Rezoning Application: PD 24-0789
Zoning Hearing Master Date: October 28, 2024
BOCC CPA Public Hearing Date: December 10, 2024

This is a request to rezone a parcel to Planned Development (PD) to facilitate a 24-unit residential townhome development at a density of 8.16 dwelling units per acre.

Reference: Design Exception Request – E Sligh Avenue
7805 E Sligh Avenue
Folio No. 40355-0000
PD-24-0789

2.4 Proposed Site Plan (partial provided below for size and orientation purposes. See Section 8.0 for full site plan)

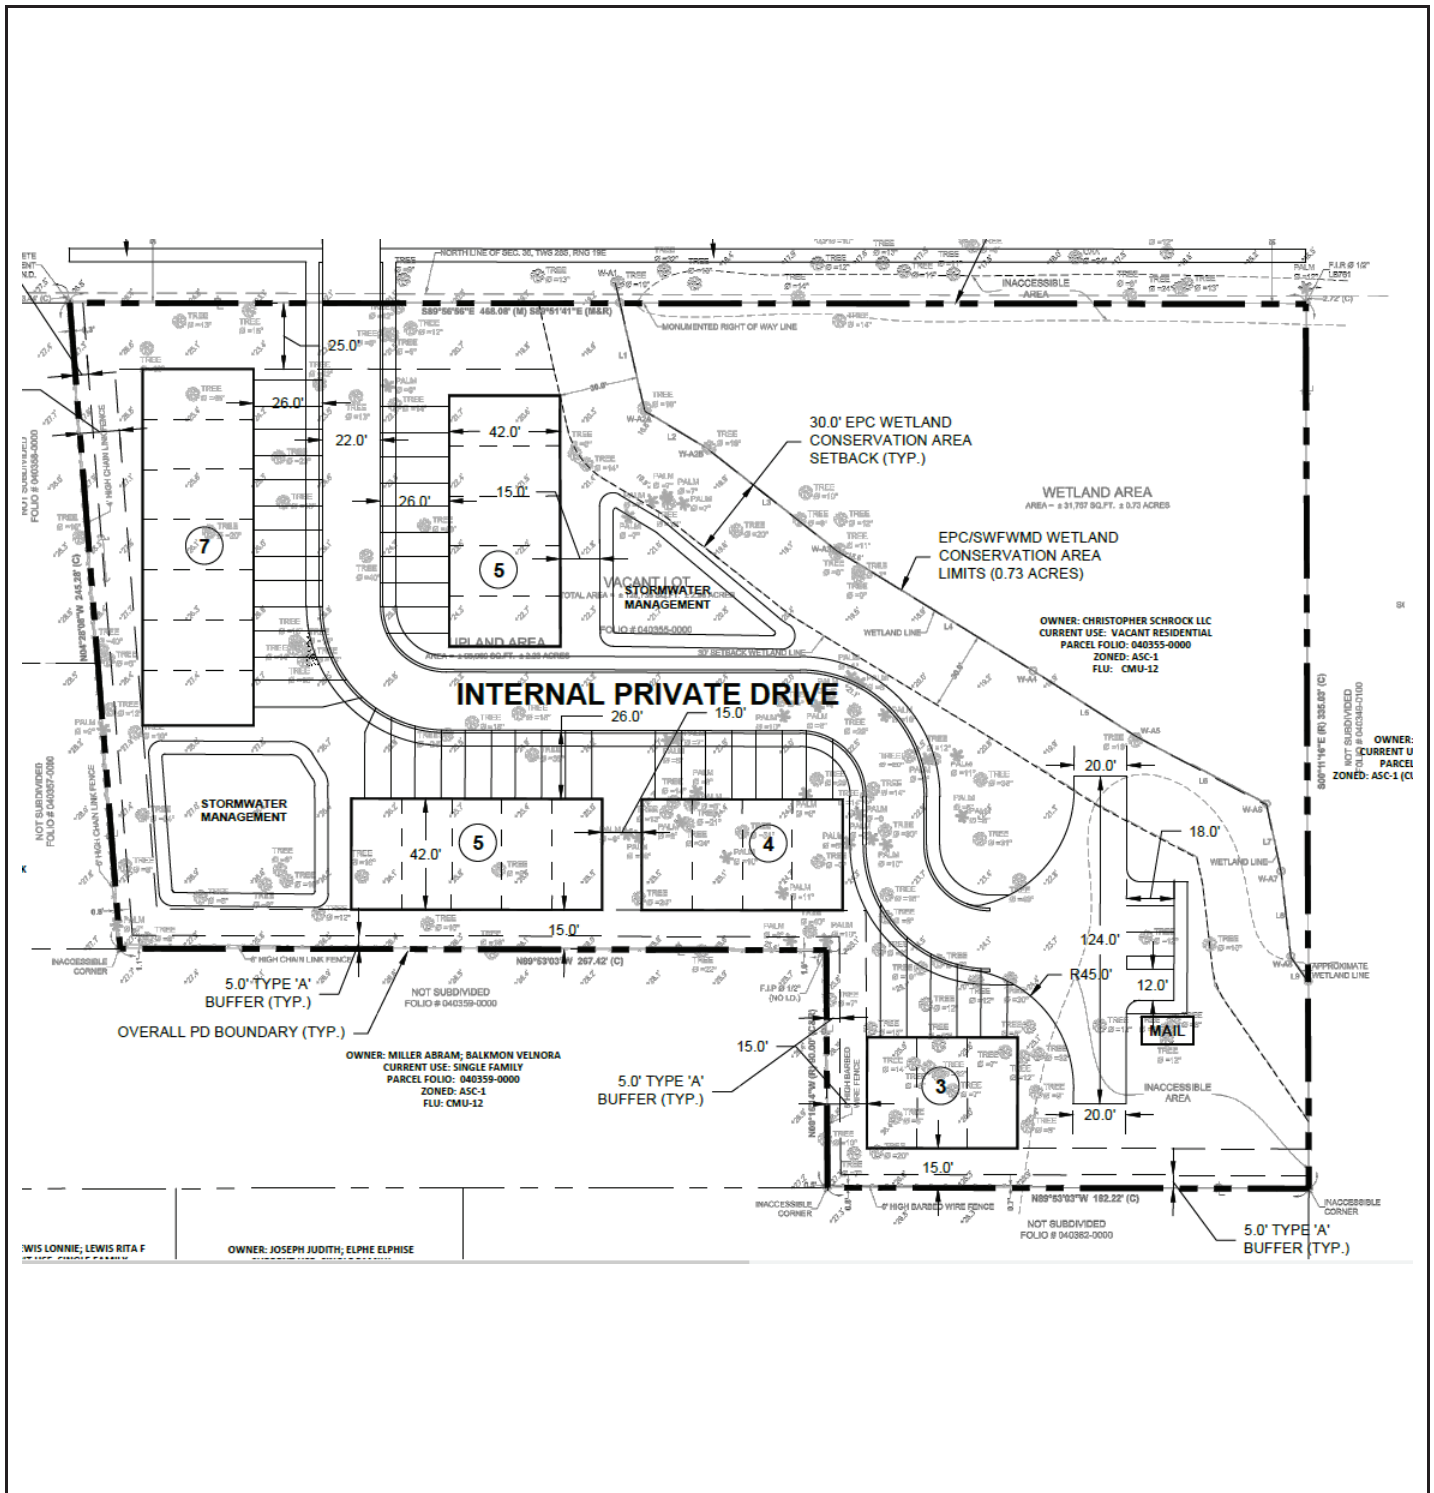
1. Prior to certification the applicant shall revise the PD site plan to include the following minimum roadway information for E. Sligh Ave along the project frontage: functional classification, right of way width, number of lanes and pavement width.
2. The applicant shall add note clearly stating the minimum lot size and width of the proposed lots.

- Prior to certification the applicant shall revise the PD site plan to include the following minimum roadway information for E. Sligh Ave along the project frontage: functional classification, right of way width, number of lanes and pavement width.

Exhibit 2 – Proposed Western Typical Section

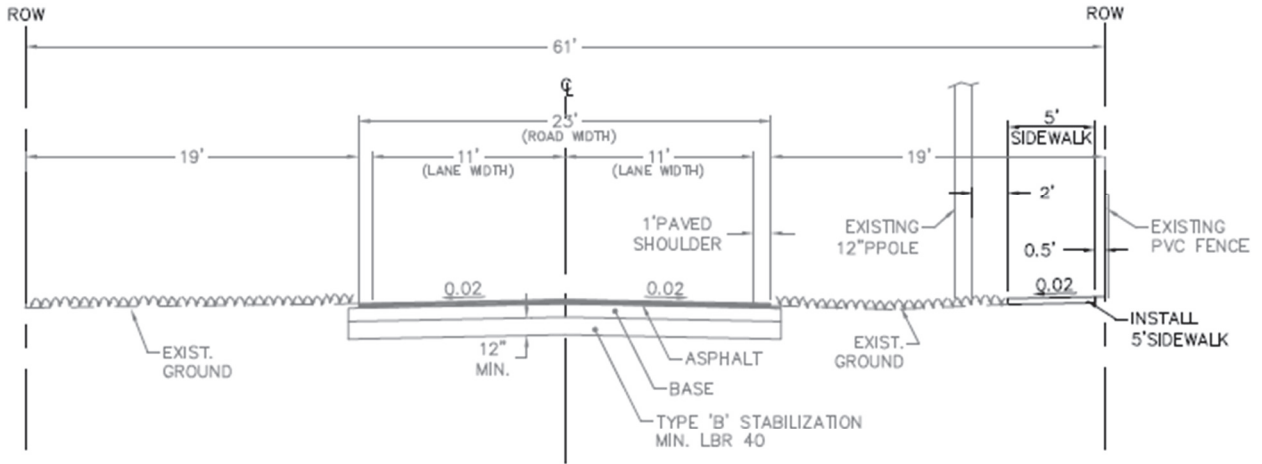
For the western section, the requested exceptions are to the TS-7 typical section and the justifications are as follows:

1. The existing ROW along Sligh Avenue is approximately 100 feet; however, there is an existing wetland within the existing ROW along both sides of the roadway. The typical TS-7 section for a rural, two-lane undivided roadway requires a minimum of 96 feet of ROW with 12 foot travel lanes, 5 foot paved shoulder, open drainage, and a 5 foot sidewalk.
2. The request is to maintain the existing 11.0 foot travel lanes and relatively flat unpaved shoulder/open drainage. The missing segments of the 5.0' concrete sidewalk on the south side of Sligh Avenue will be completed, which will add approximately 350 linear feet of sidewalk. Based on Table 210.2.1 of the FDOT Design Manual, the 10-foot travel lanes identified as acceptable.

The proposed western section typical section is shown in Exhibit 2 and the proposed improvements are shown in Exhibit 3.

Exhibit 4 – Proposed Eastern Typical Section

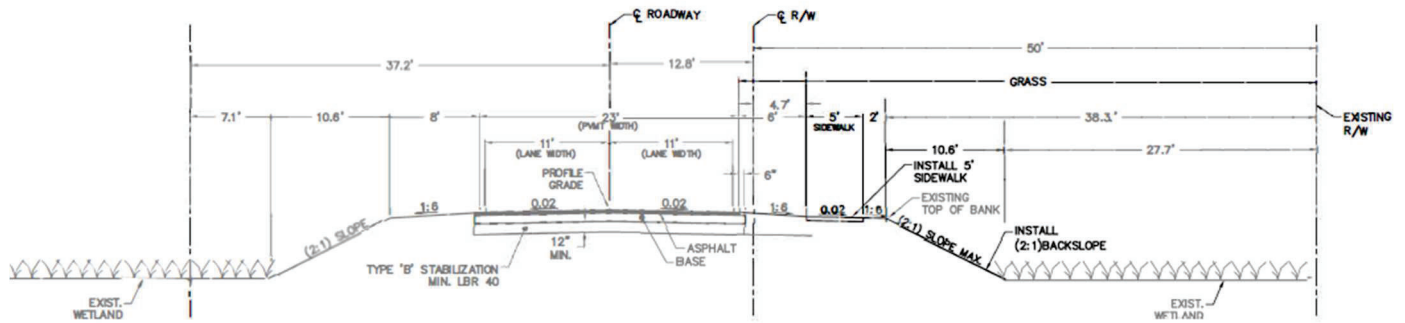
For the eastern section, the requested exceptions to the TS-7 typical section and the justification are as follows:

1. The existing ROW along Sligh Avenue is approximately 100 feet; however, there is an existing wetland within the existing ROW along both sides of the roadway. The typical TS-7 section for a rural, two-lane undivided roadway requires a minimum of 96 feet of ROW with 12 foot travel lanes, 5 foot paved shoulder, open drainage, and a 5 foot sidewalk.
2. The eastern section currently has 11 foot travel lanes in approximately 100 feet of ROW. The request is to maintain the existing 11 foot travel lanes and add approximately 1,300 linear feet of 5' concrete sidewalk along the south side of Sligh Avenue, with a 6 foot grass strip on the south side of Sligh Avenue and a 2 foot grass strip along the back side of the sidewalk. Due to ROW constraints and existing conditions, the slope to the wetland may exceed to 4:1 slope, but will not exceed 2:1.

The proposed eastern typical section is shown in Exhibit 4.
